# TECHNICAL INFORMATION COMMUNICATION

**Number:** TIC2026-0001

**Title:** Factory Refrigerant Charge Update

**Product Category:** Residential Ducted Split Systems

**Charging label & rating plate:** Reverting back to 15ft. refrigerant amounts.

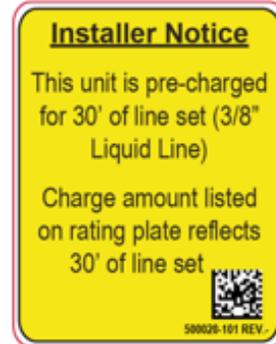
**Installer notice label:** Removed from standard refrigerant charged units.

**Increase pre-charge shipping label:** Light gray (independent of manufacture year).

**Standard charge shipping label:** Yellow (2026 manufacture year)
